MFN 08-313

Subject: **Response to Portion of NRC Request for Additional Information Letter No. 152 - Related to ESBWR Design Certification Application – RAI Number 4.3-12**

NRC RAI 4.3-12

NRC Summary: Describe the Feedwater Temperature Control System

Figure 4.2-1 from NEDO-33338.

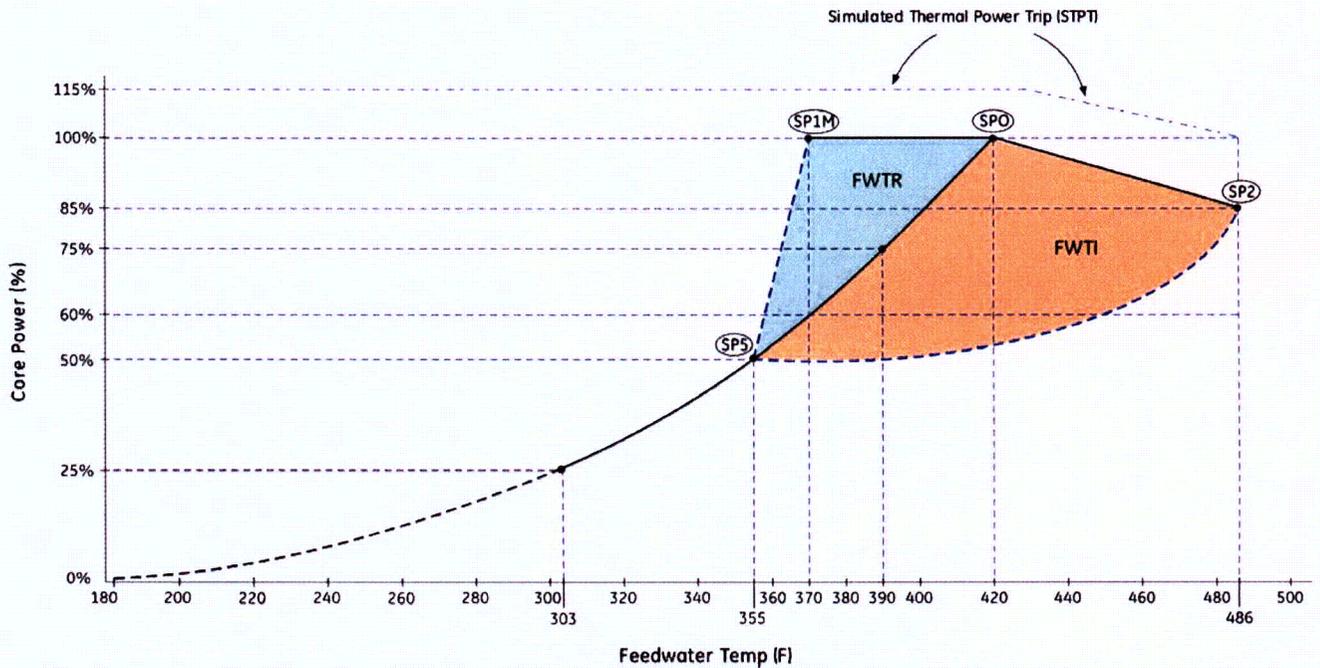
Provide a description of the FWT control system design and logic. Provide a figure showing the location of the relevant sensors important to the operation of the FWT control system. Describe how the design meets the requirements for the condensate and feedwater system specified in Subsection 10.4.7.1.1 of DCD Rev.4.

Independent of FW level control, triple redundant FW Temperature (FWT) control is also designed for the ESBWR to allow reactor power maneuvering without moving control rods. The ESBWR High Pressure (HP) Feedwater Heater Temperature Control Diagram is provided in DCD, Tier 2, Figure 7.7-7. FWT control is accomplished by either manipulating the main steam flow to the #7 FW heaters to increase FWT above the temperature normally provided by the FW heaters with turbine extraction steam (normal FWT) or by directing a portion of the FW flow around the high pressure FW heaters to decrease FWT below the normal FWT. An increase in FWT decreases reactor power and a decrease in FWT increases reactor power. At 100% Rated Thermal Power (RTP) conditions, the addition of seventh stage FW heaters in full service provides approximately 36.7°C (66°F) increase in the FWT, which corresponds to approximately 15% core power reduction. ESBWR reactor power versus FW temperature map (Power-FWT Map) is described in LTR NEDO-33338 Figure 4.2-1. The figure is reproduced here and will be included in DCD, Tier 2, Revision 5, Section 4.4.

ESBWR Power – Feedwater Temperature Operating Domain/Map
